**CERTIFICATE OF APPROPRIATENESS**

**Property:** 128 W 17<sup>th</sup> Street, Lots 13 & 14, Block 133, Houston Heights Subdivision. The property is a vacant 5,330 square foot (65' x 82') corner lot.

**Proposal:** New Construction – Three-story 4,532 square foot brick veneer mixed-use building

WEST ELEVATION – FRONT FACING YALE STREET

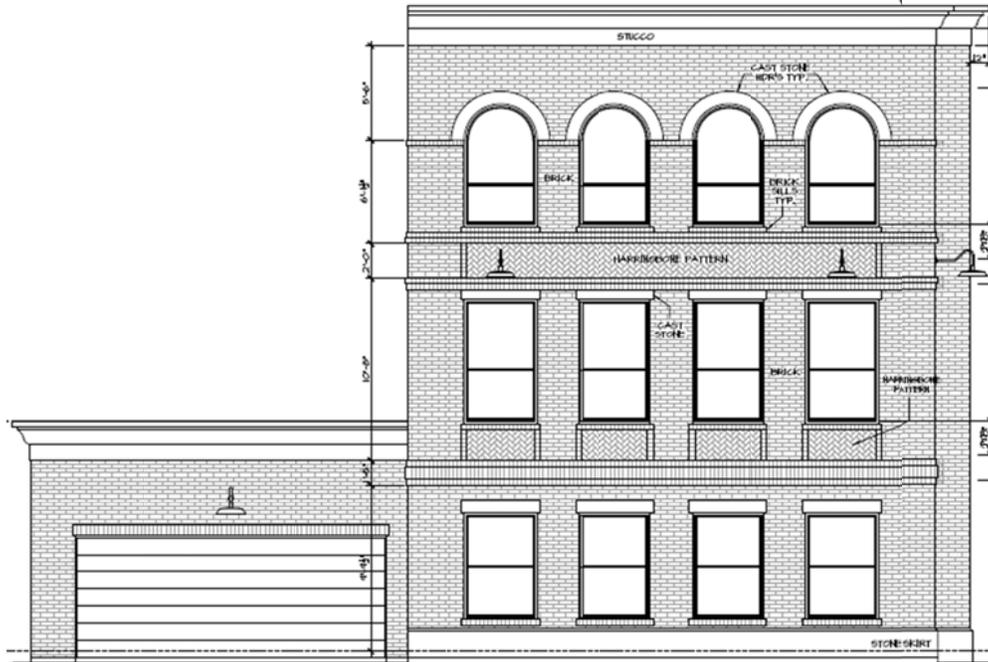
The applicant has resubmitted an application for a COA. The revised proposal is identical to the previously denied proposal with the exception of an overall height decrease of 1', from approximately 38' (37'-10") to 37' (36'-10"), driven by a 1' decrease in the first floor plate height (from 10' to 9'.)

*At three stories and 36'-10" tall, the proposed structure is 7'-4" and a full story taller than the tallest contributing commercial structure in Heights East.*

**Recommendation:** Denial - does not satisfy criteria

### SITE PLAN

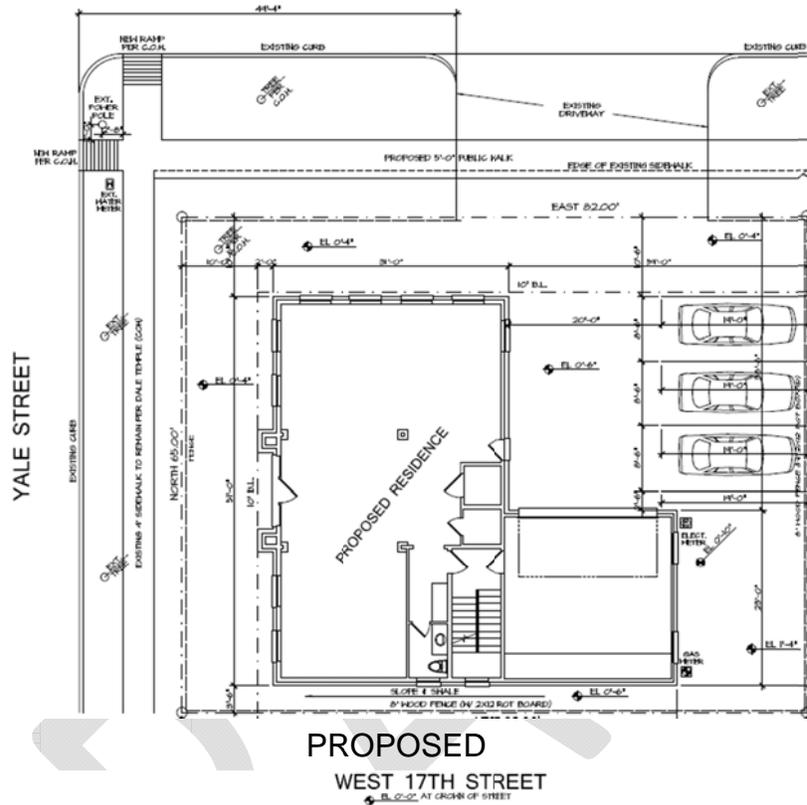
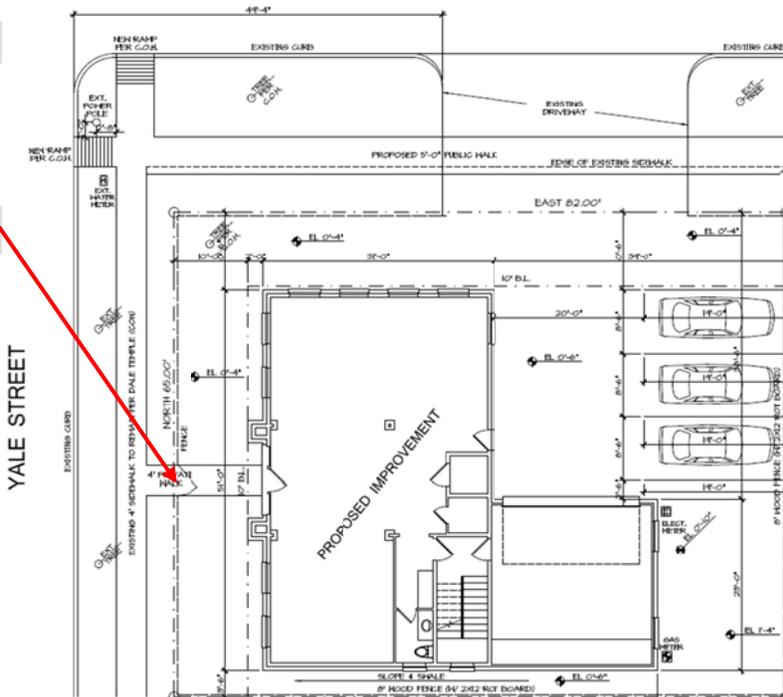
ADDITION OF SIDEWALK ACCESS ONLY PROPOSED CHANGE
